CHANGE ORDER NUMBER: 1HNTB Corporation
Round Rock

Project:	<u>1811-278</u>
Roadway:	<u>Forest North-Anderson Mill</u>
CSJ Number:

**Forest North-Anderson Mill
Williamson County Project No. 1811-278**

Change Order No. 1

WILLIAMSON COUNTY
FOREST NORTH DRAINAGE IMPROVEMENTS
CHANNEL SF4-1 PLAN AND PROFILE - START TO END

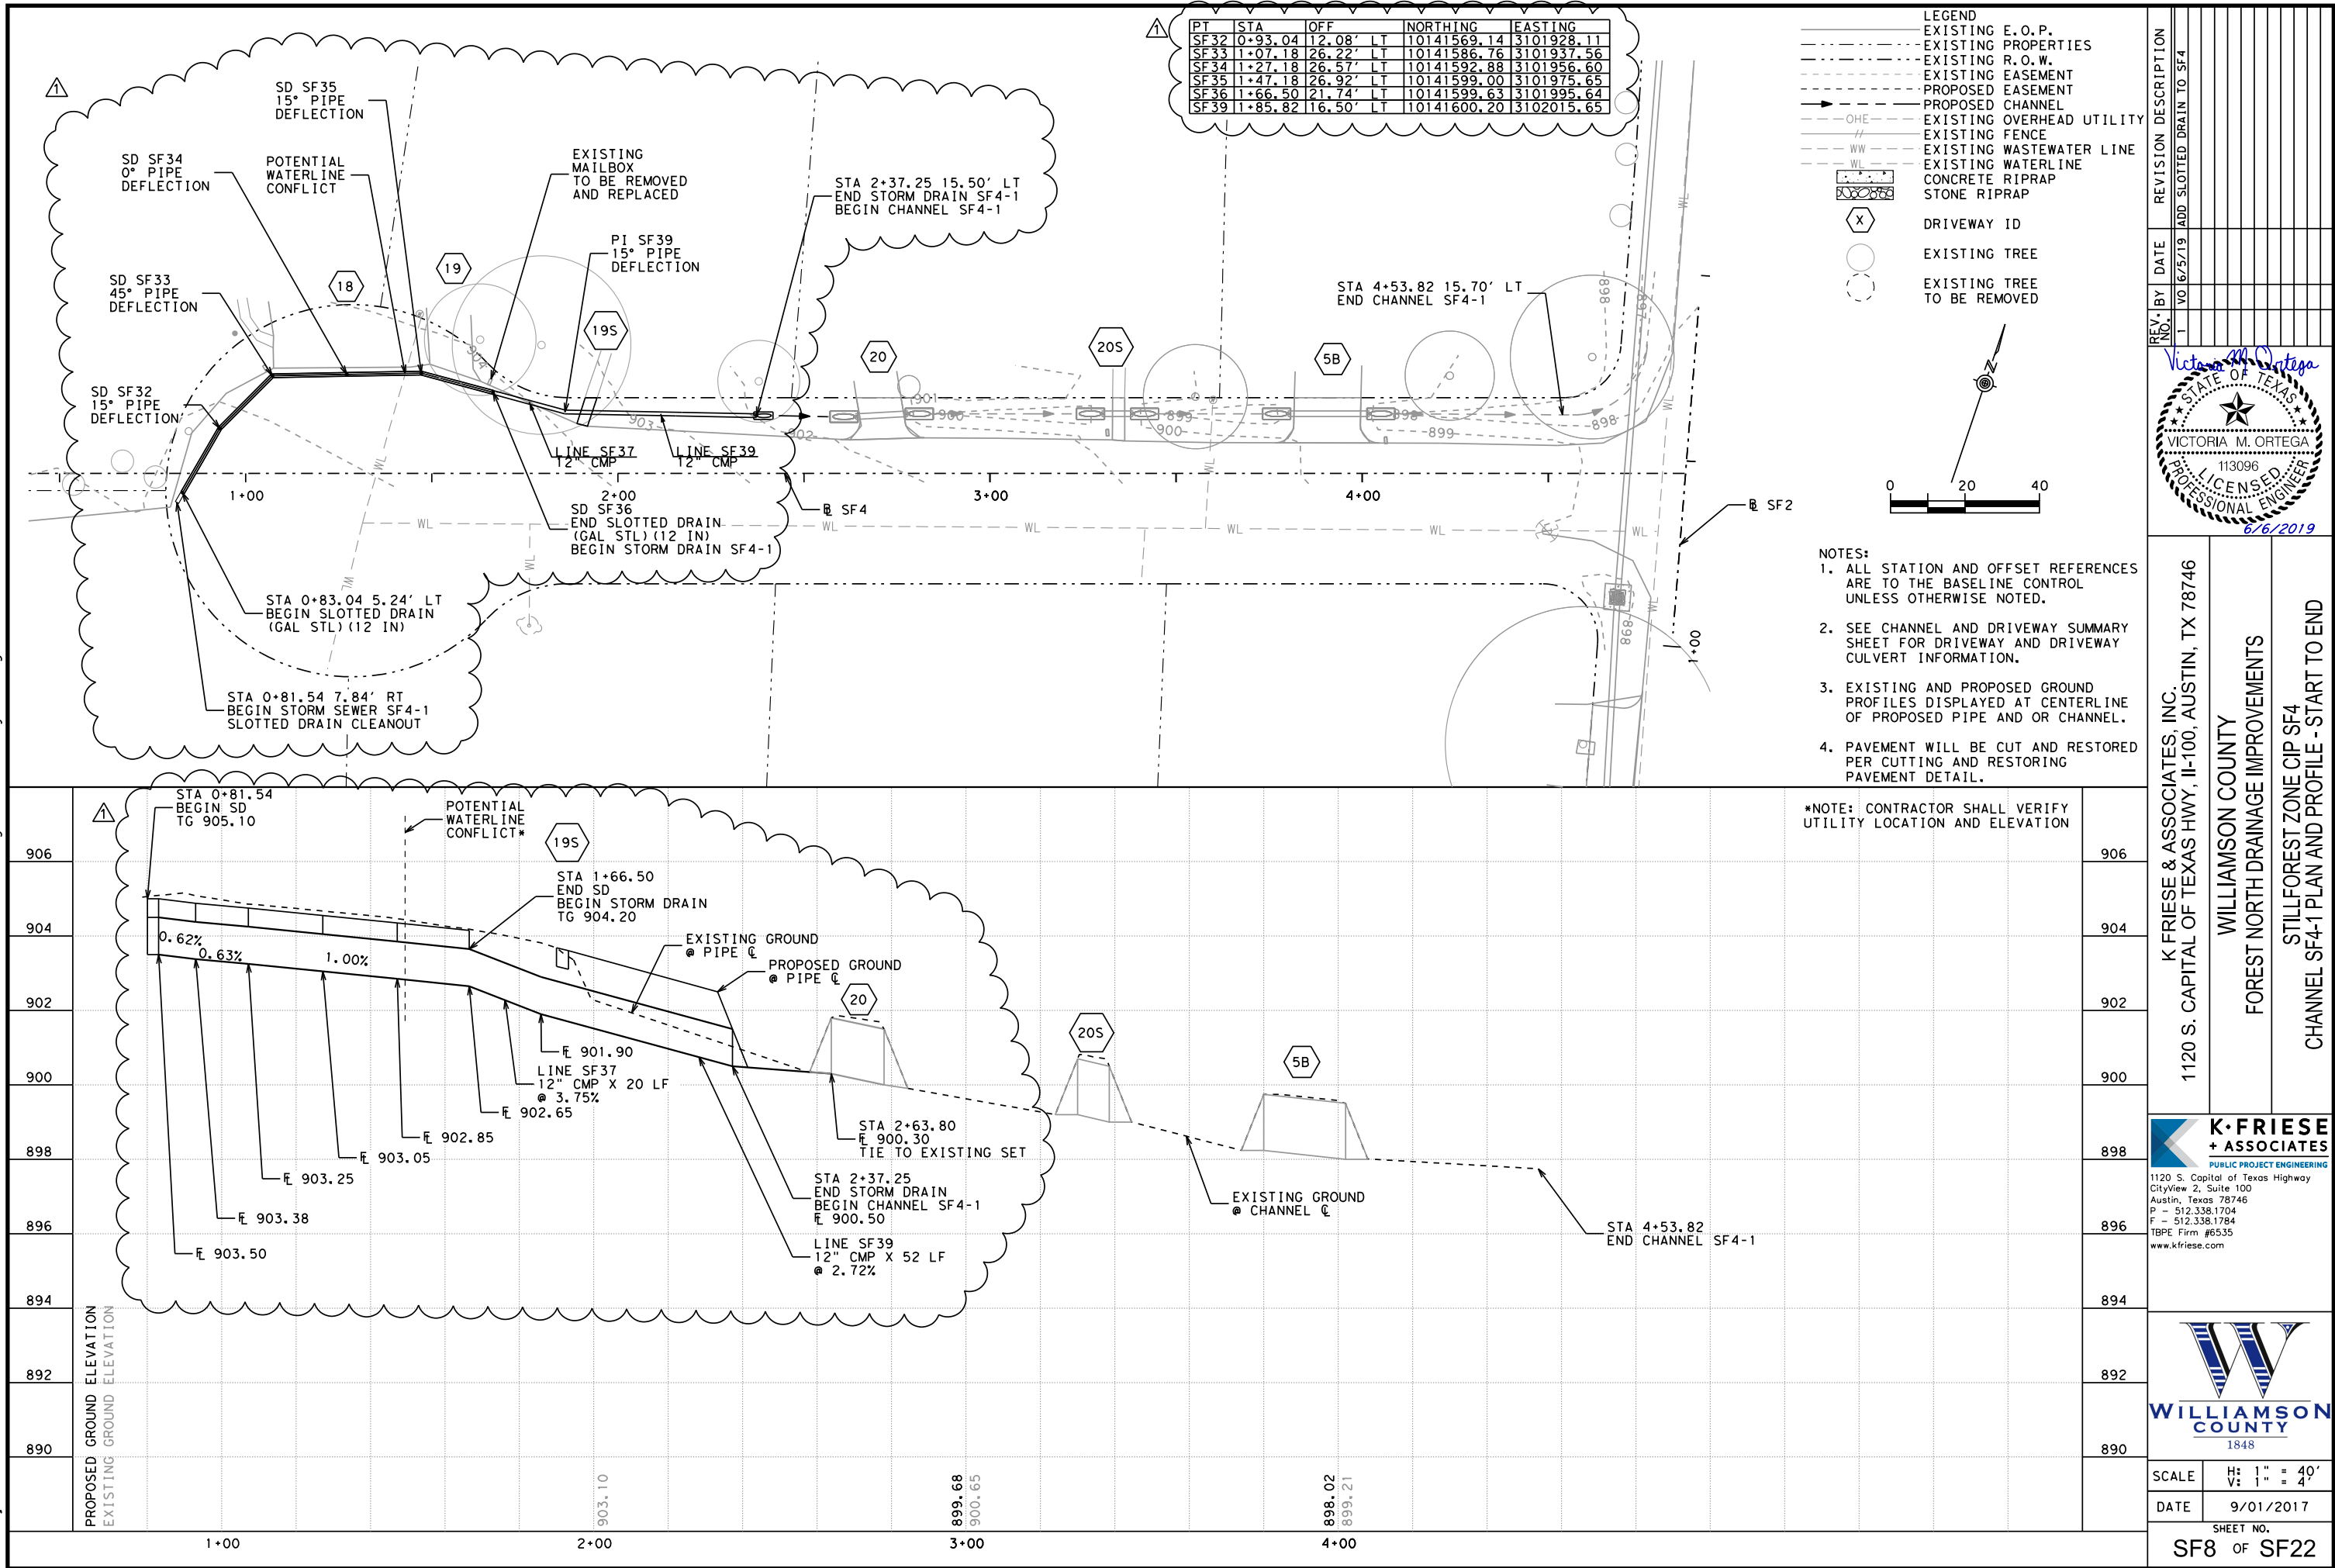
REV.	NO.	BY	DATE	REVISION DESCRIPTION
1		VO	6/5/19	ADD SLOTTED DRAIN TO SF4

WILLIAMSON COUNTY
FOREST NORTH DRAINAGE IMPROVEMENTS
STILLFOREST ZONE
CHANNEL AND DRIVEWAY SUMMARY

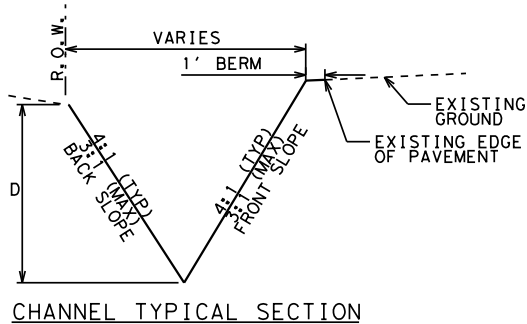
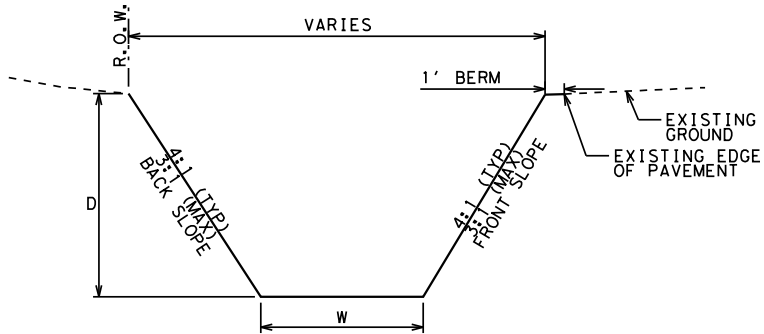
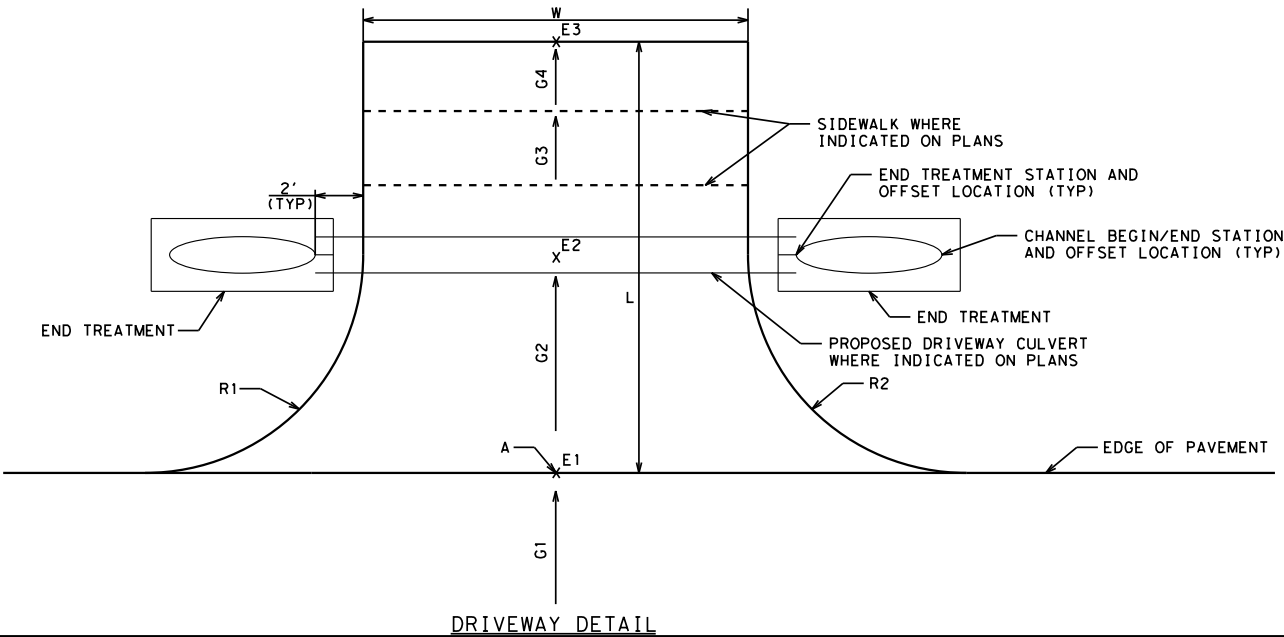
REV. NO. 1
REV. BY VO
DATE 6/6/19
REVISION DESCRIPTION
ADD SLOTTED DRAIN TO SF4

STORM SEWER HYDRAULIC CALCULATIONS

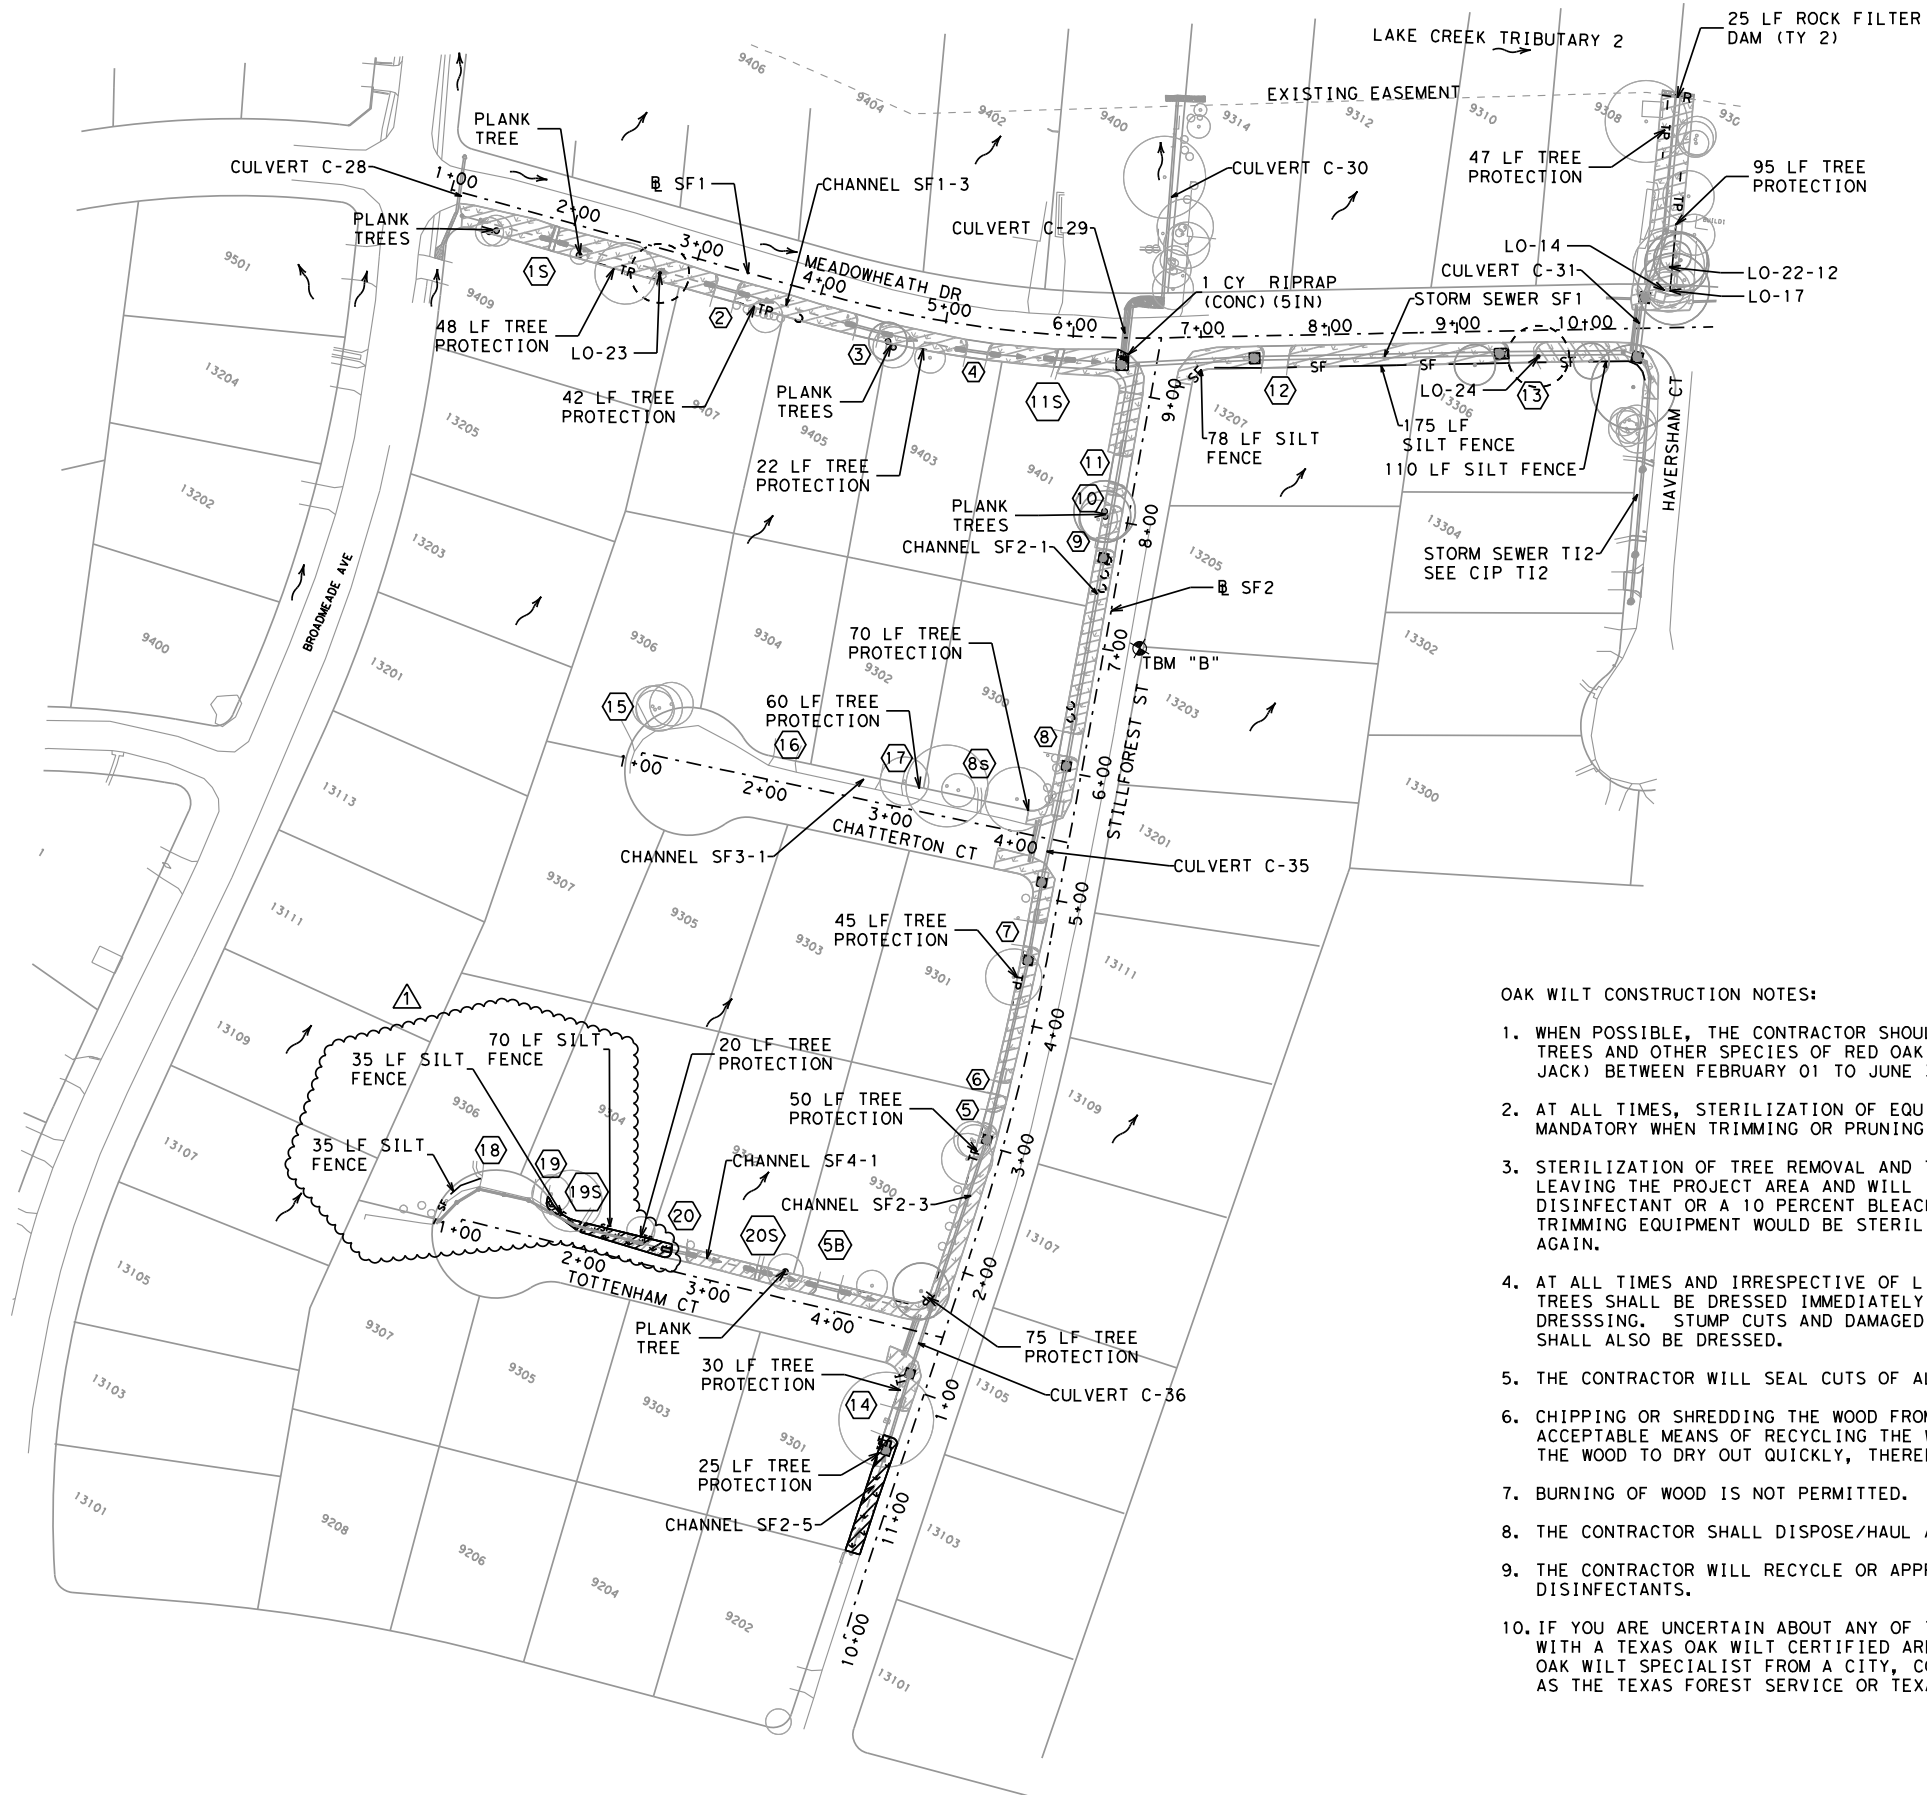
ADD SLOTTED DRAIN TO SF4

PHOTO #2

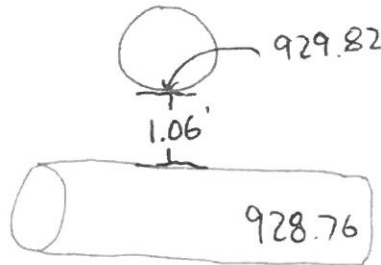
On Pothole 2, Alley behind pre school:

Bottom of existing waterline - 929.82
Top of proposed storm- 928.76
Difference- 1.06'

AWU agrees that the lines are determined to not be in conflict and so can be removed from the scope of the project.

#1

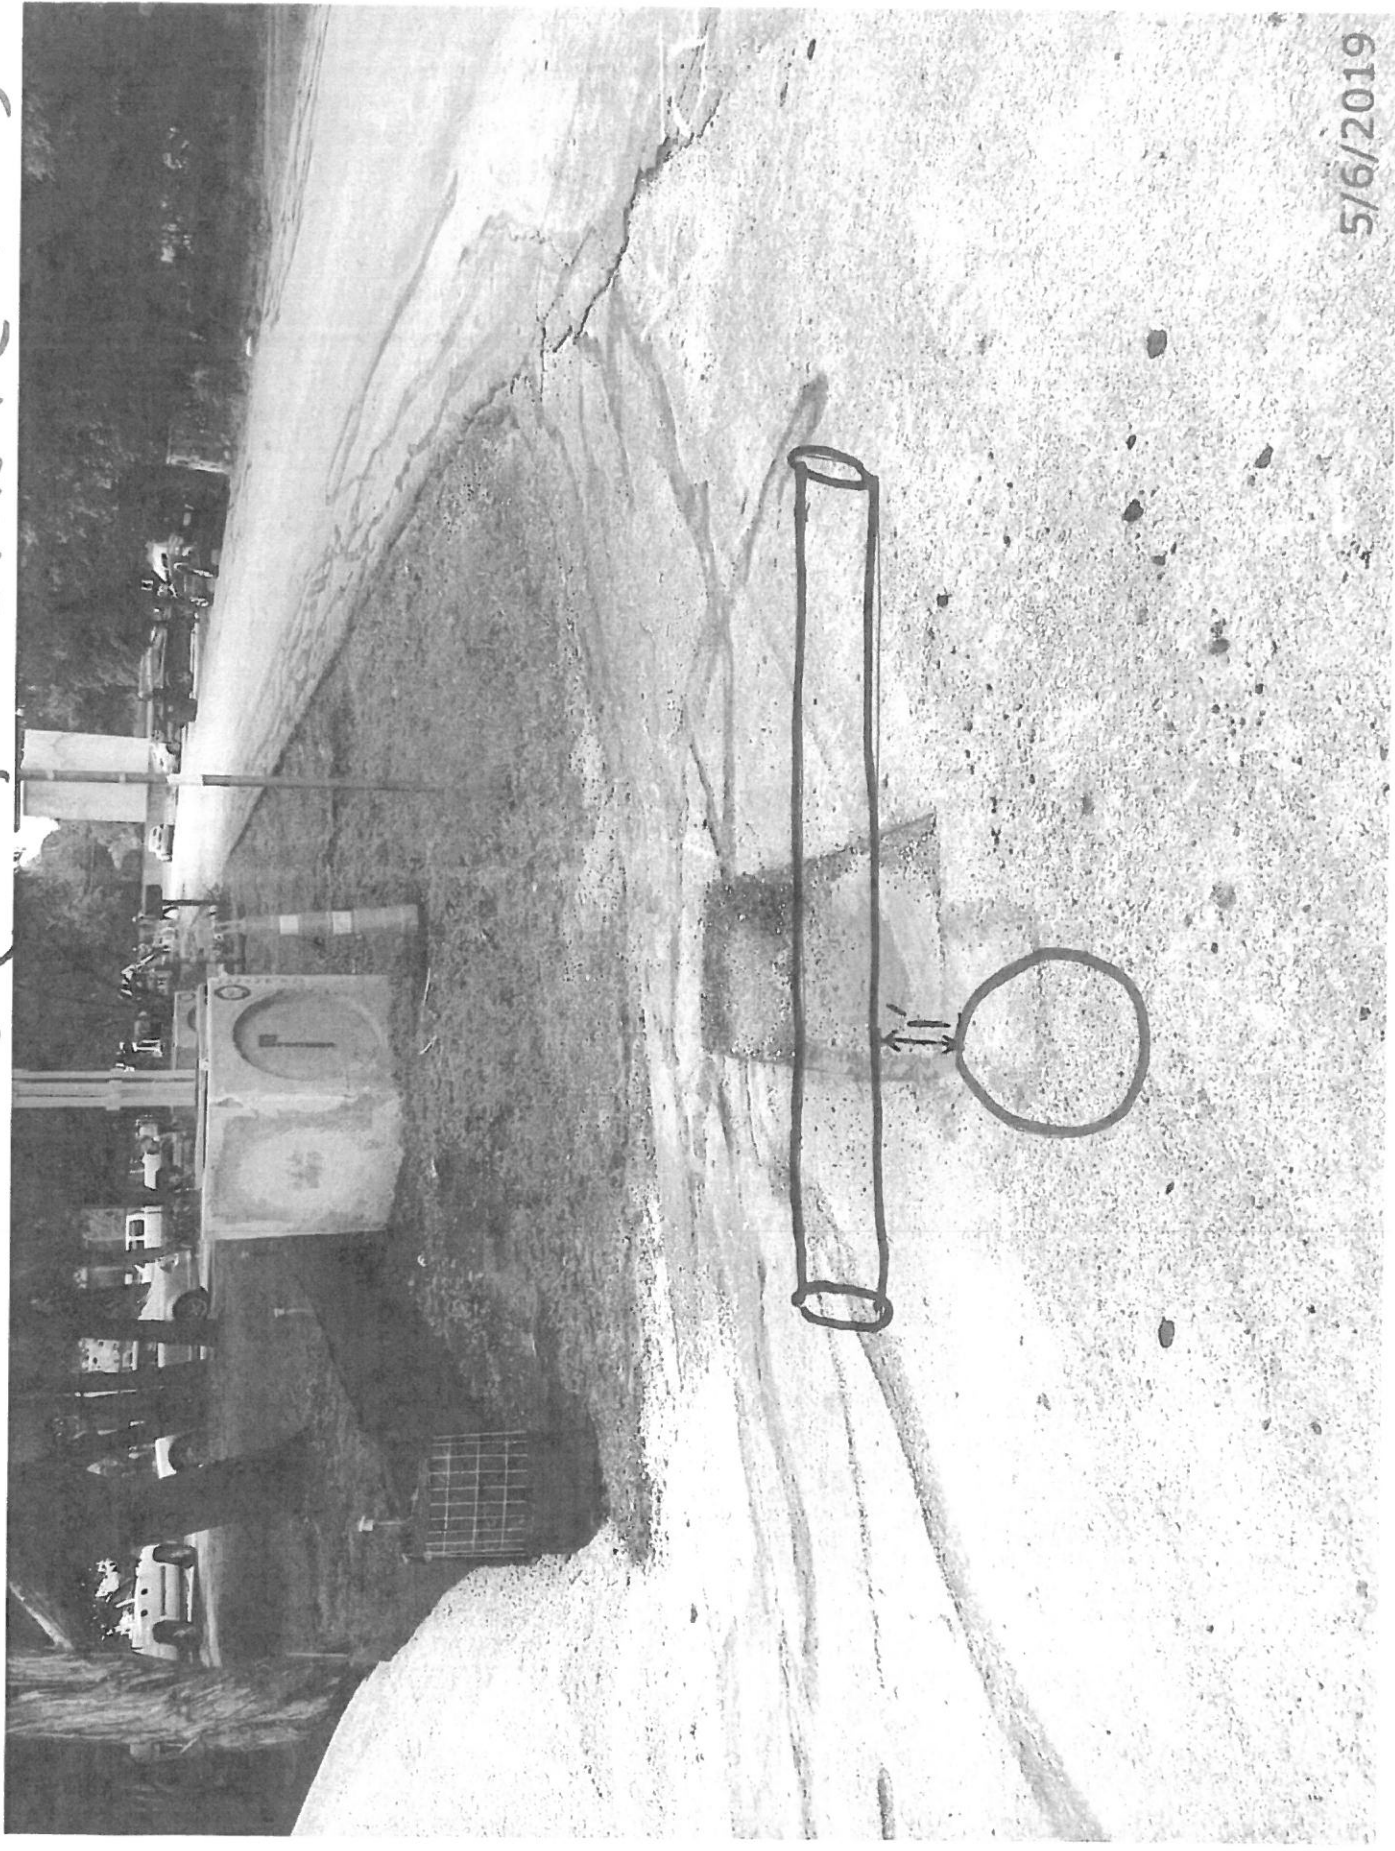
Can all proposed waterline relocation/installation be removed from the contract due to the current separation distances shown on the attachments? Photo #1 references Sheet C-103. Photo #2 references Sheet C-104. Photo #3 references Sheet C-102 at Station 1+42. Photo #4 references Sheet C-102 at Station 2+25.

On pothole 1, Sherbourne and Roxborough:

Bottom of existing waterline - 933.90
Top of proposed Storm- 932.90
Difference - 1'
